Environmental Review Team Report

# Grayville Falls Park

Hebron, Connecticut

August 1980

# PROPOSED DEVELOPMENT PLAN

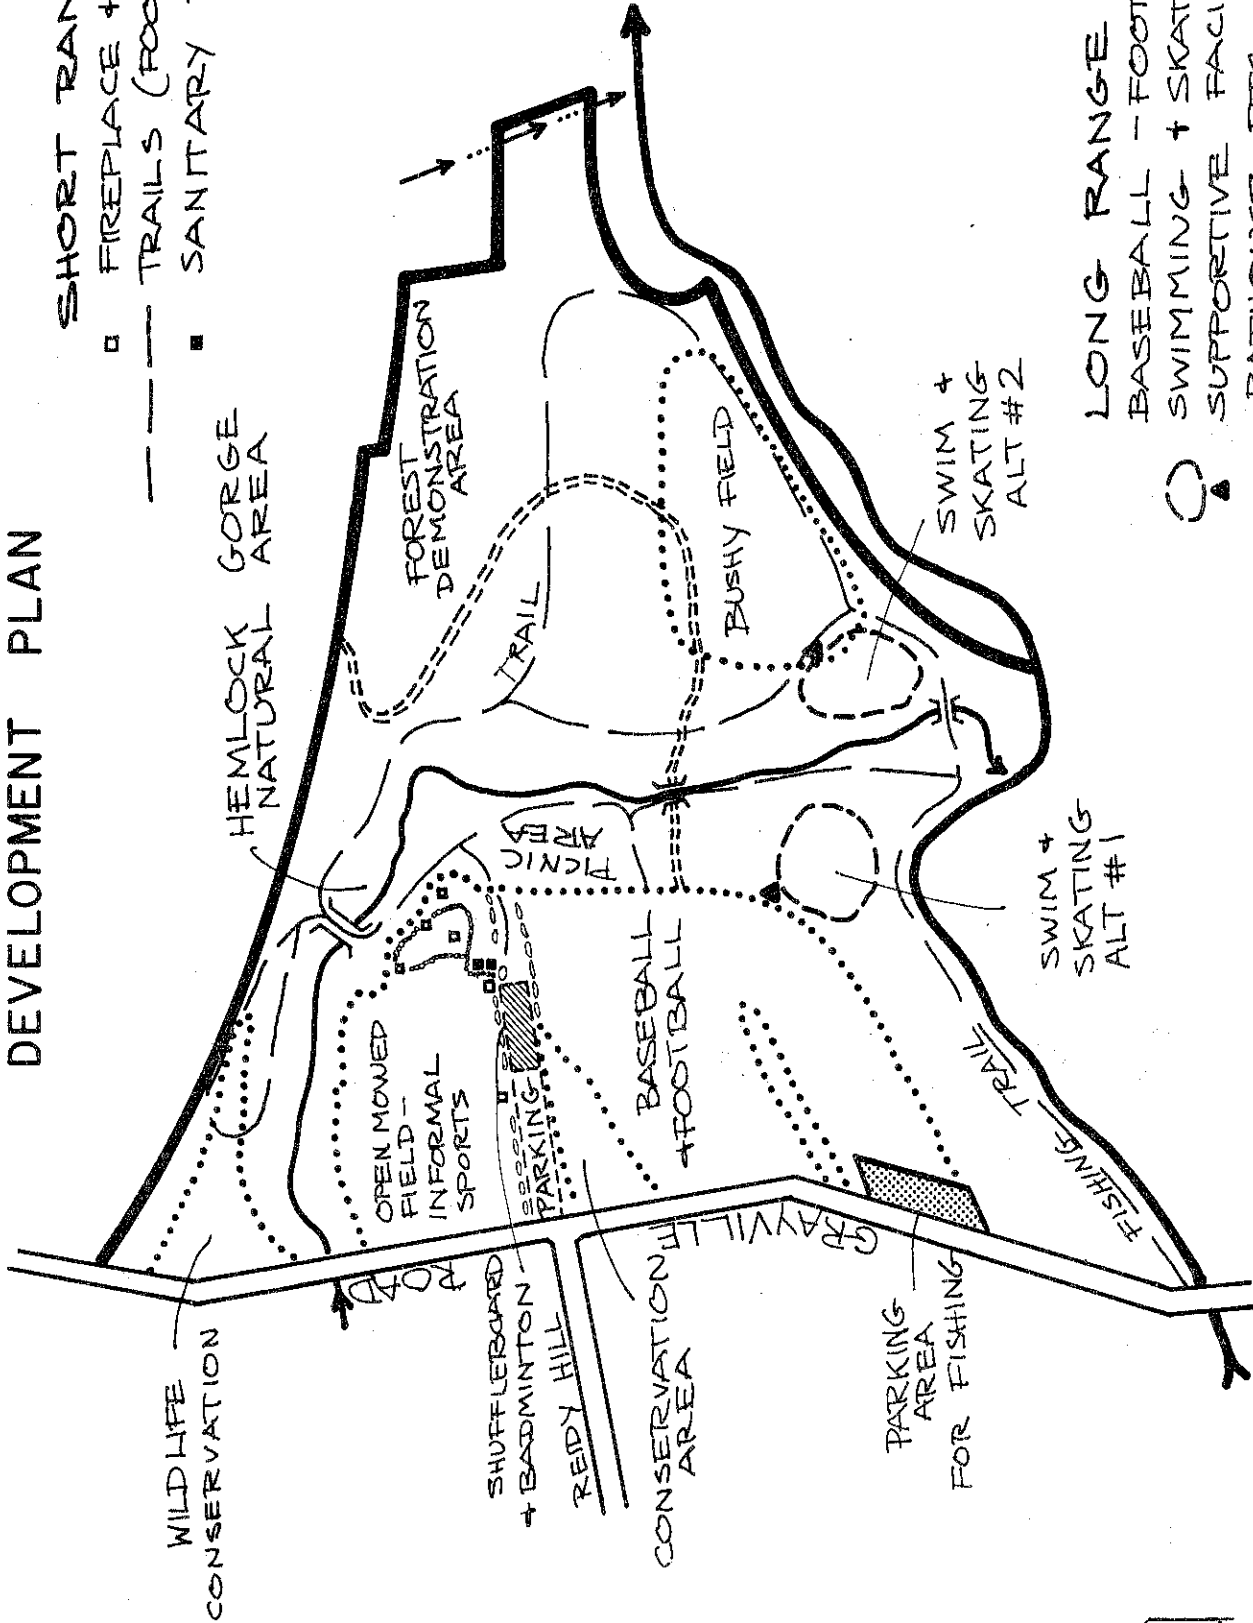
The tentative plan offered for development of the tract appears reasonably sound in concept. The proposal for a swimming area may be difficult to implement however. Stream flow and dilution rates expected during times of peak summer use should be determined and also the ramifications of a swimming area established here, on downstream water quality. If the waters feeding from this point downstream are being used for public drinking water, the swimming proposal would have to be eliminated. The swimming proposal does not appear to be a highly feasible component of a plan for development. Swimming is ordinarily a desirable component of a recreational area when it can be provided, however.

If the brushy field (so called on the conceptual sketch map) is kept open by periodic mowing, this would enhance the options for informal uses such as frisbee toss, kite and model airplane flying, pickup ball games, and other open field type activities when the fields near the parking areas are in full use. The wetland characteristics of the soils would serve to limit its usability.

Sledding and tobogganing on the pathway connecting the footbridge to the "brushy field" to the south of the stream appears to be possible on at least a portion of the trail, after some trail improvement work.

In regard to the northern or active recreation portion of the tract, the proposed plan offers activities appropriate to what the site can accommodate. Terracing by cut and fill method, may be necessary to provide for maximum use

of the area being proposed for baseball, football, and parking. Supplemental parking will be necessary to accommodate the additional ballfields and expanded picnic facilities. Additional picnic sites could be accommodated in the stand of spruce and old apple trees located on the southern end of the proposed baseball and football fields.

An access road which crosses the stream and connects to the "brushy field" is shown on the proposed sketch map. There is currently no bridge crossing the stream affording access to the "brushy field". The expense associated with erecting a vehicle bridge appear prohibitive when weighed against the potential benefits derived from providing cross-stream vehicle access. Soils lying south of the stream offer limited potential for recreational development because of slope and wetness. Site modification costs necessary to accommodating active recreation facilities would further add to the development costs. The pattern of soil types found and the limited accessibility accordingly make for convenient zones of recreational use. These zones could provide active recreation to the north of the stream and passive recreation to the south.

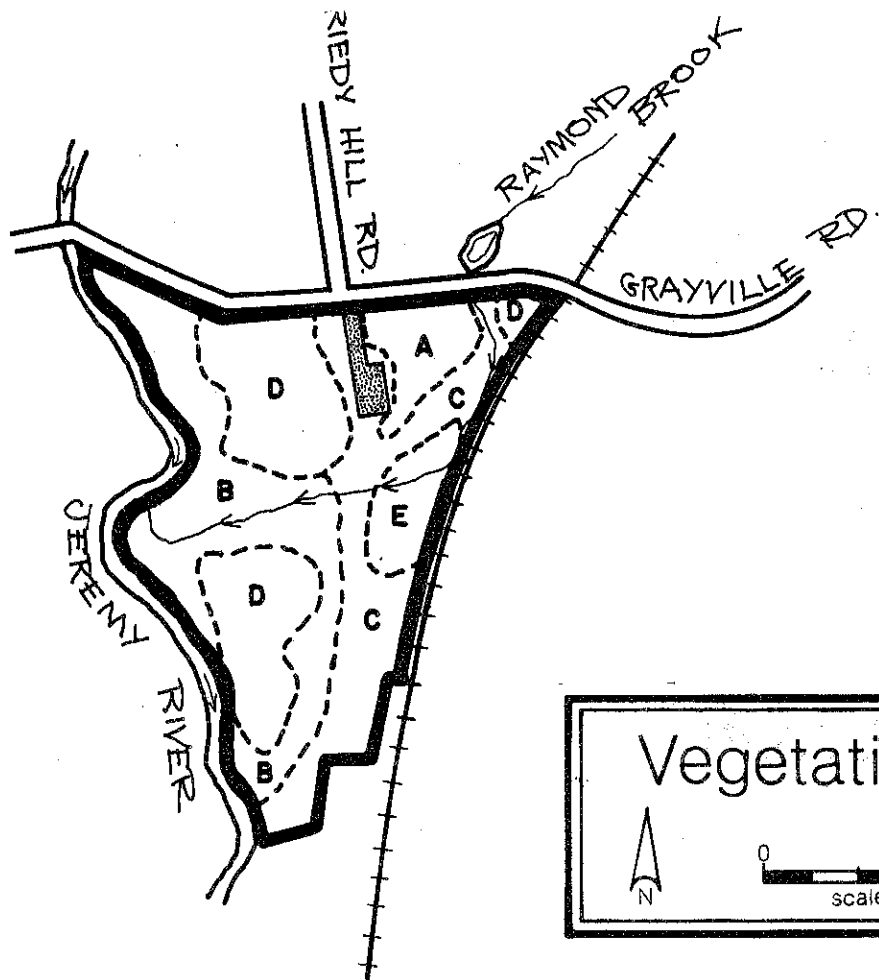
Development of the proposed baseball fields, football fields, parking lots, sanitary facilities and also the establishment of ponds for swimming and skating will require complete removal of woody vegetation in the areas set aside for these activities. Some of this development may take place in the old fields, reducing the amount of forested areas being cleared. The size of the areas to be cleared and the amount of woody vegetation to be removed will depend largely on the extent of this development. The changes in water relations as a result of this development should not have a major impact on surrounding vegetation. These areas should be revegetated with sod as soon as possible after development to prevent erosion.

Development of this nature on this parcel will also require extensive grade changes. These grade changes should be kept to a minimum near trees that are going to be retained for their aesthetic and shade value, to avoid causing them injury.
